PROJECT SCOPING PLAN FOR PERFORMING A CERCLA
REMEDIAL INVESTIGATION/FEASIBILITY STUDY (RI/FS) AT
THE FILL AREA WEST OF BUILDING 135 (SEAD-59), AND THE
ALLEGED PAINT DISPOSAL AREA (SEAD-71), SENECA ARMY
DEPOT ACTIVITY

APRIL 1997

**PROJECT SCOPING PLAN
REMEDIAL INVESTIGATION/FEASIBILITY STUDY
AT SEAD-59 and SEAD-71
SENECA ARMY DEPOT ACTIVITY
ROMULUS, NEW YORK**

**FIGURE 1-2
 SITE PLAN**

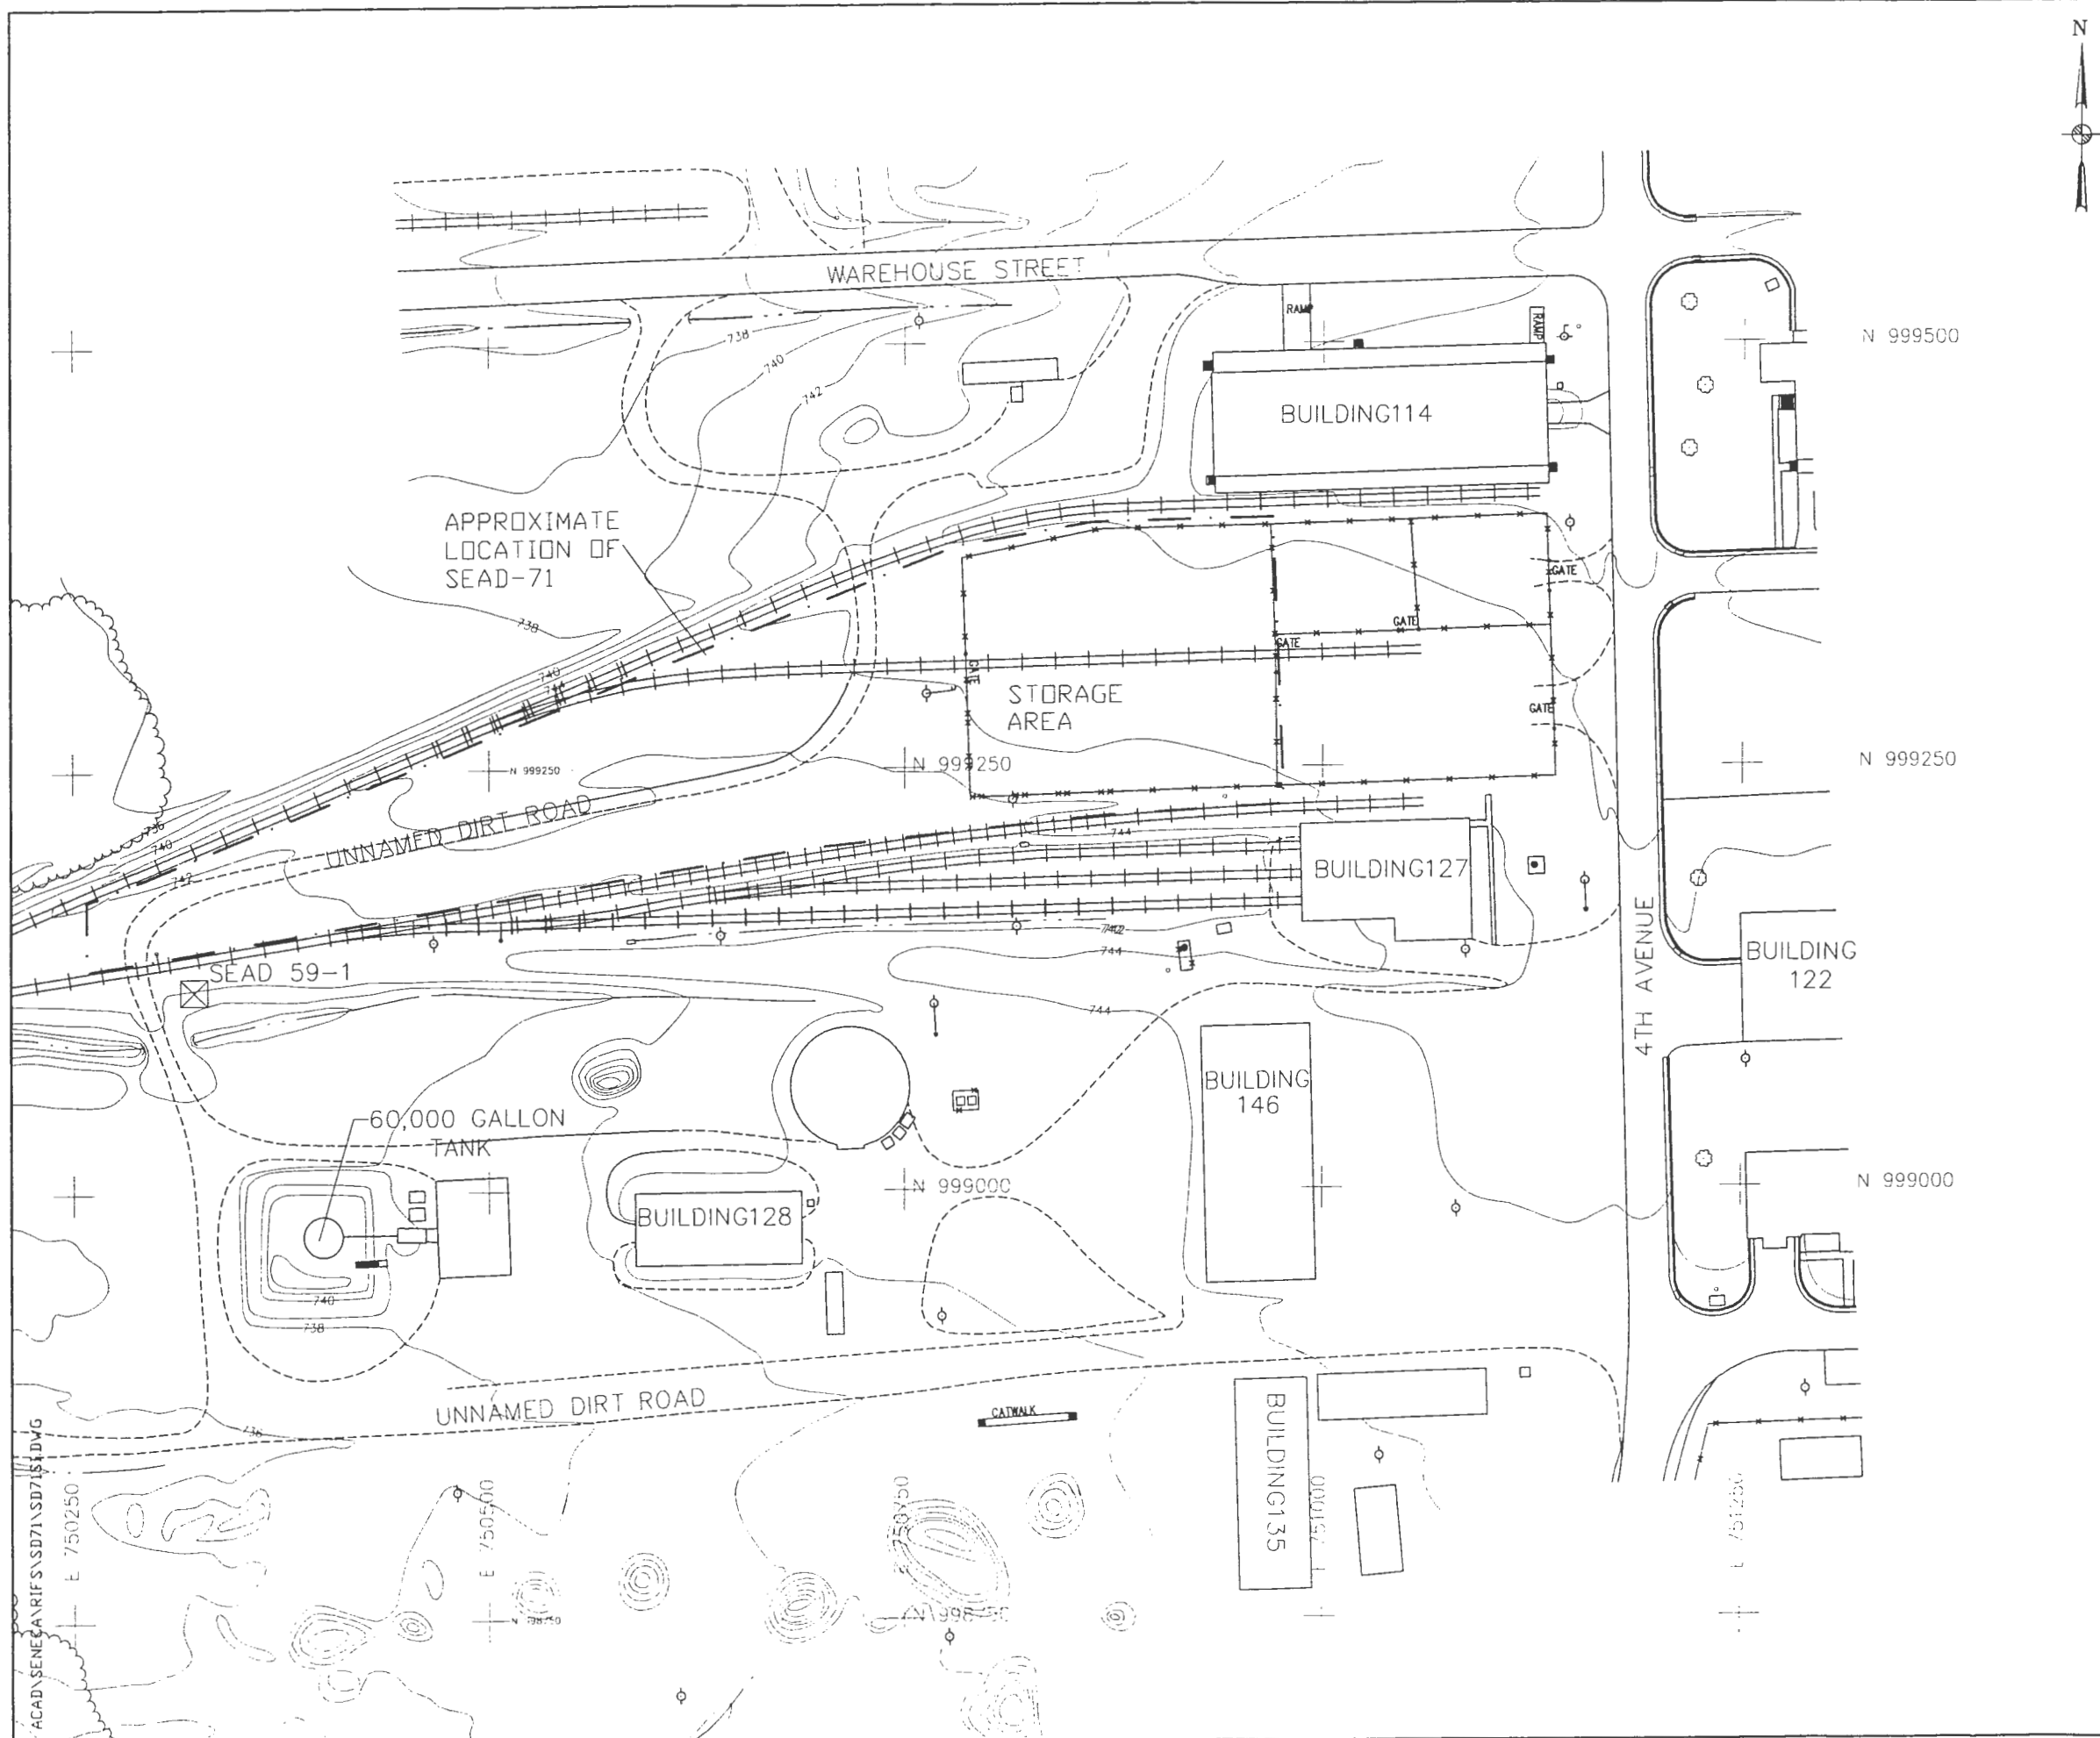
Comment #1 Figure 1-3: Based on the results of Test Pit TP59-1 (BTEX of 2,100,000 ug/kg) the area of the AOC delineated in Figure 1-3 should be expanded.

Response #1 Agreed. The extent of the area that defines SEAD-59 has been extended to the south as recommended in the comment. Figure 1-2 (formerly Figure 1-3) has been revised.

**FIGURE 3-7
GROUNDWATER ELEVATION MAP**

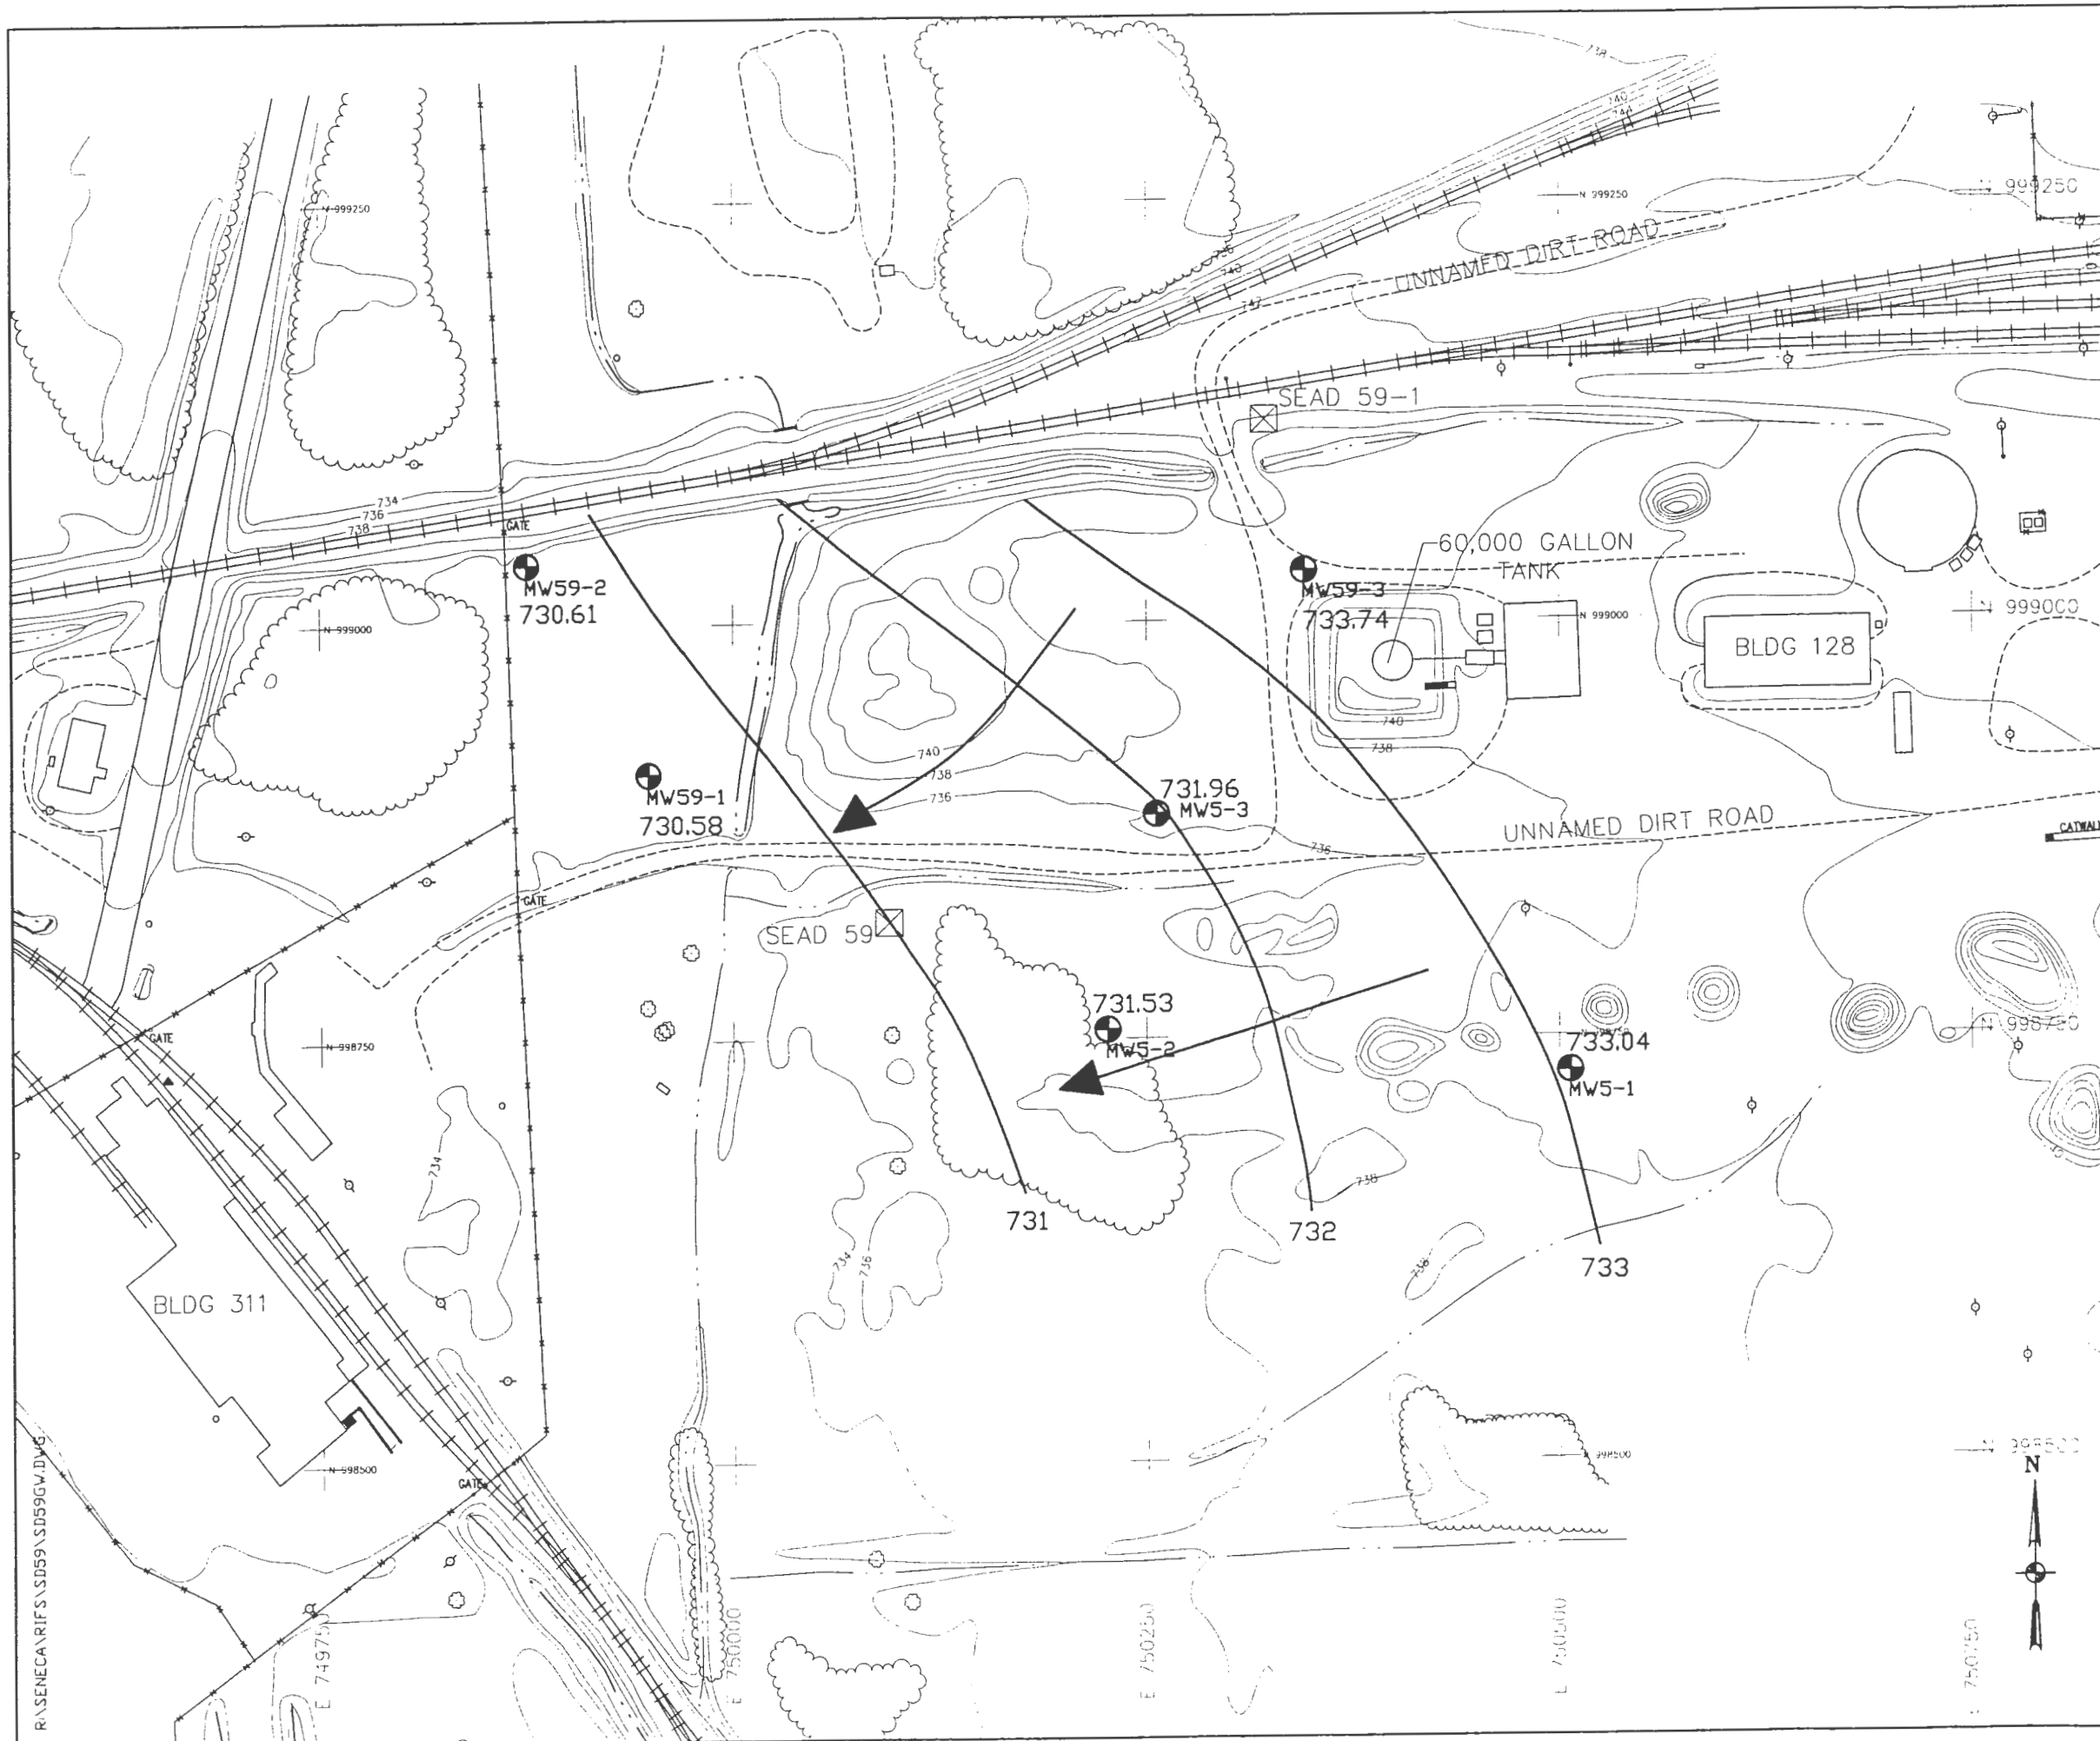
Comment #2 Figure 3-11: It is unclear what control was used to construct the 730 foot contour line presented on this figure. This same comment was made in the EPA's November 28, 1995 letter commenting on the Draft ESI Report for the Eight Moderately Low AOCs. In response to this comment the 730 foot contour was removed in the Draft Final version of this document.

Response #2 Agreed. The 730 foot contour was removed from Figure 3-7 (formerly Figure 3-11) as recommended in the comment.

FIGURE 3-9
 TOTAL PAHs IN SURFACE SOILS
 LOCATION OF ESI SAMPLING POINTS

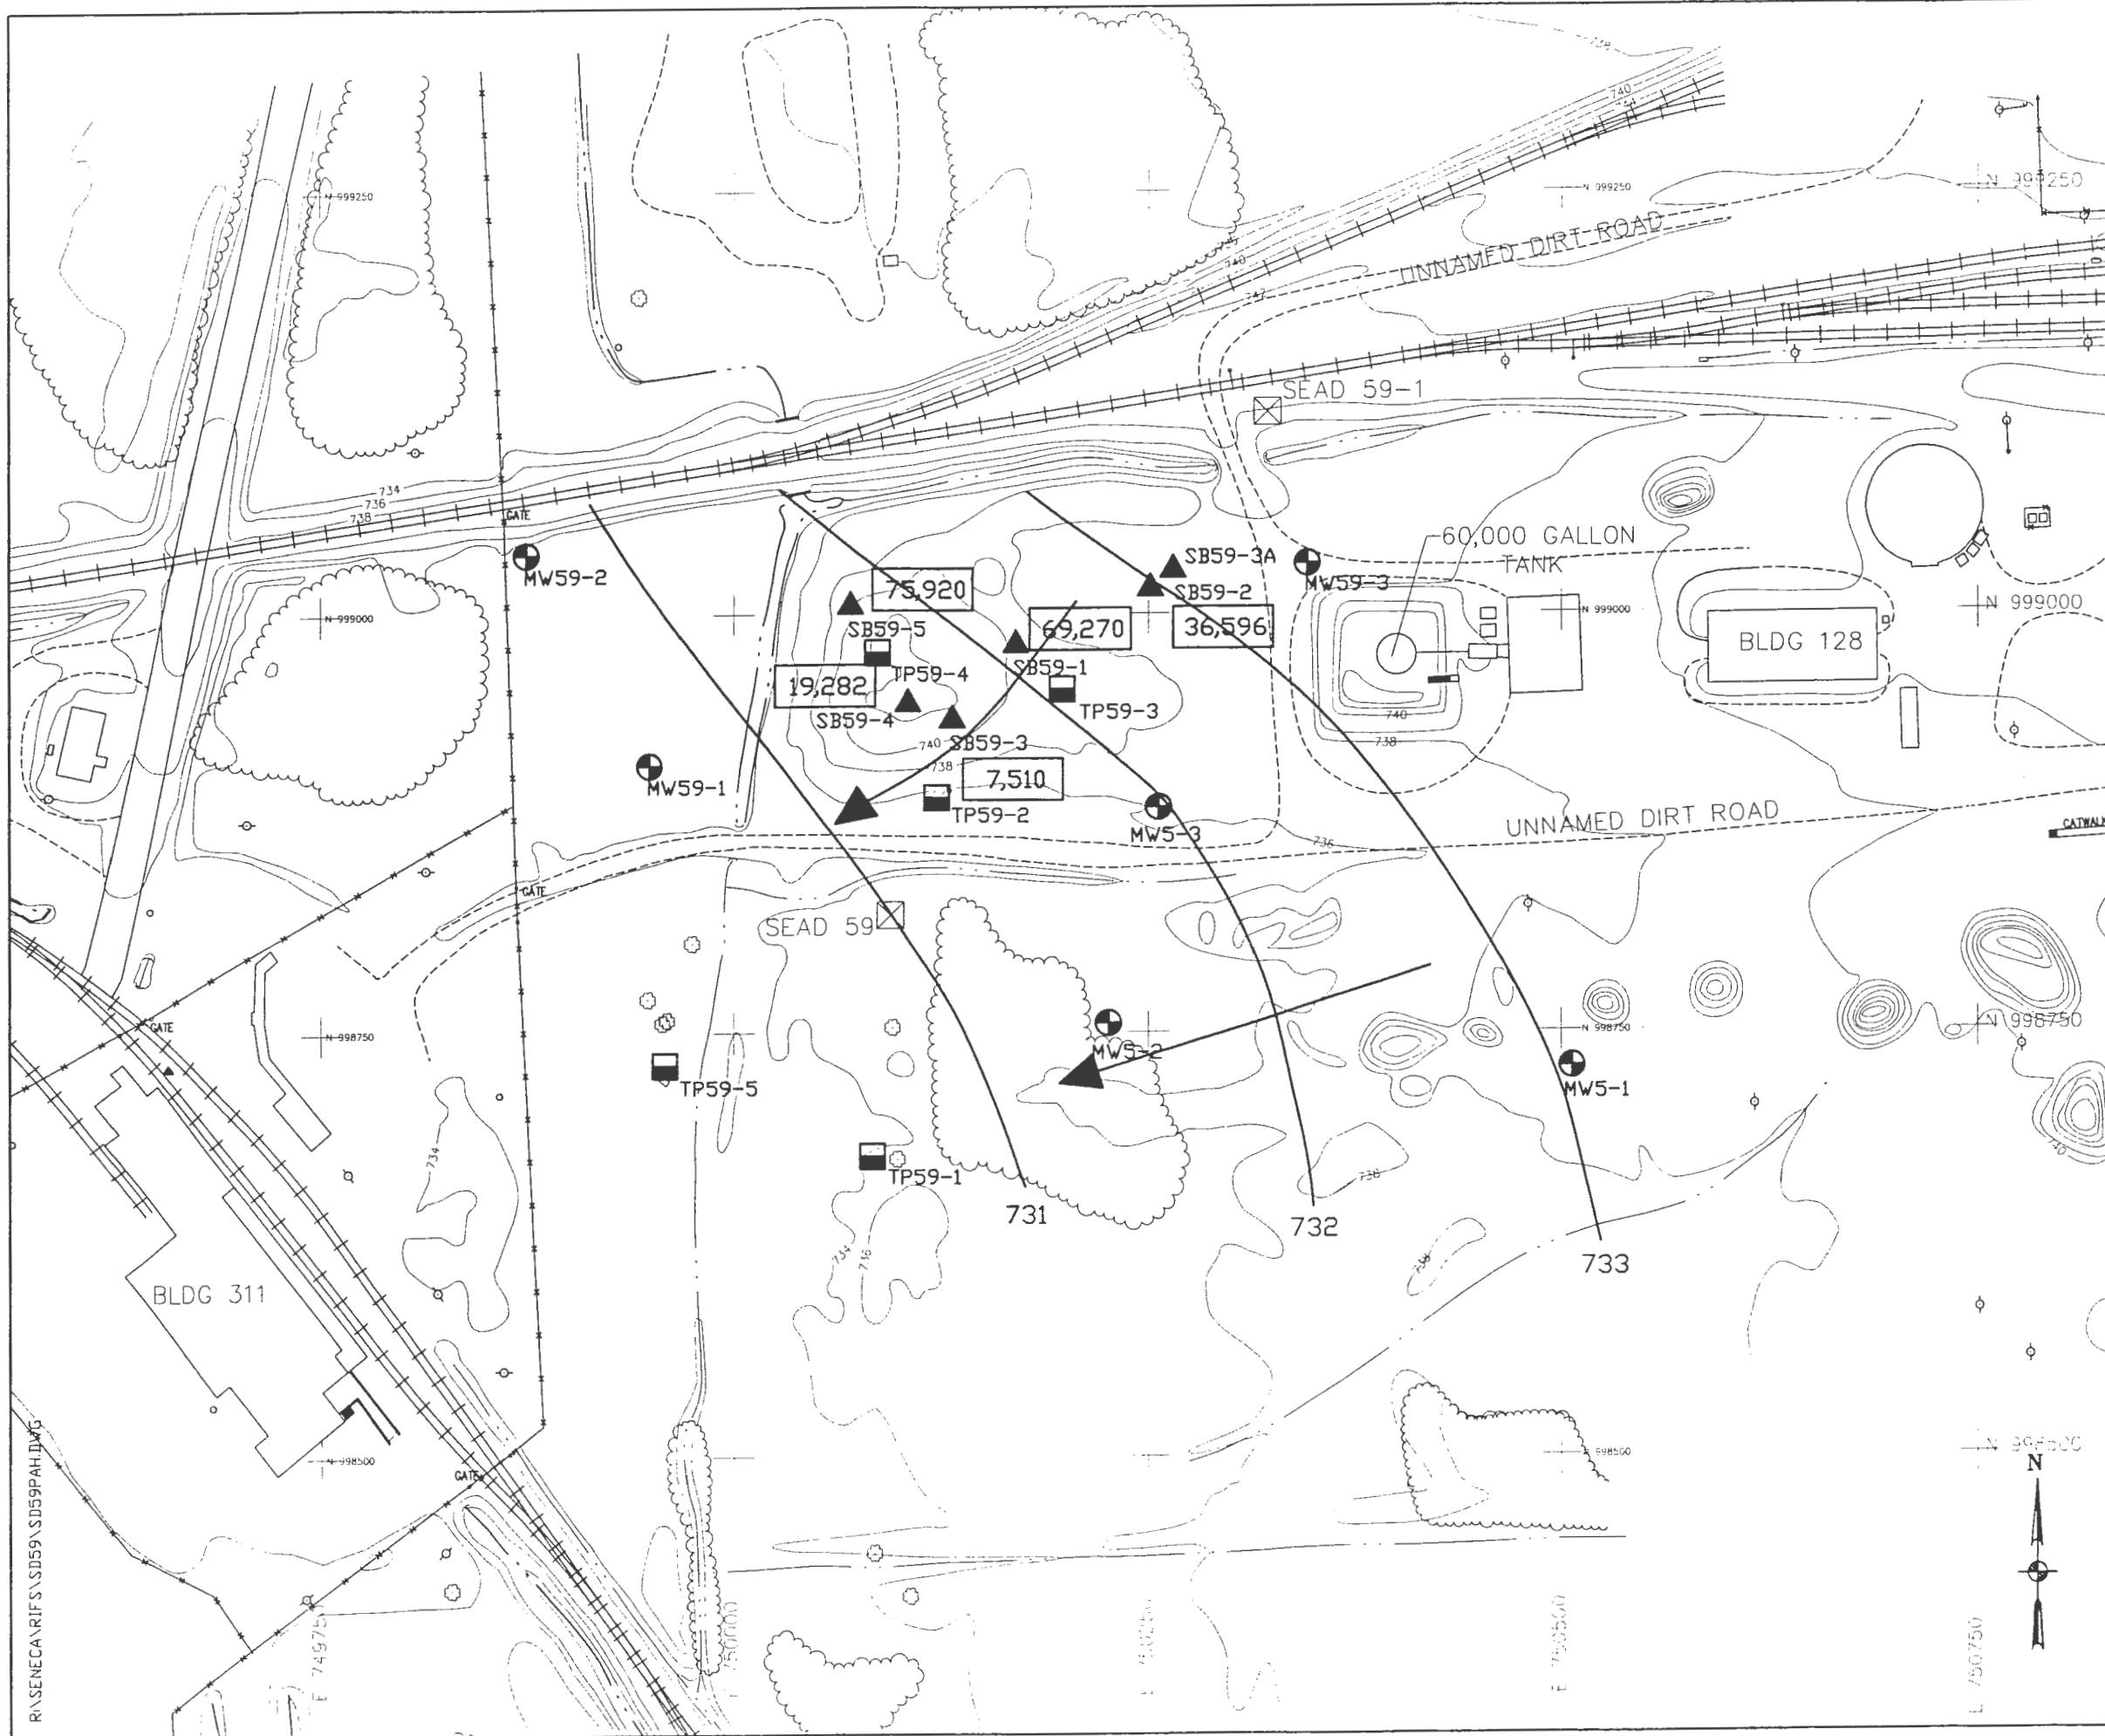
Comment #3 Figure 3-13: Monitoring wells MW5-1, MW5-2, and MW5-3 should be shown on this Figure as they are on Figure 3-11 and Figure 3-12.

Response #3 Agreed. Monitoring wells MW5-1, MW5-2, and MW5-3 were added to Figure 3-9 (formerly Figure 3-13) as recommended in the comment.
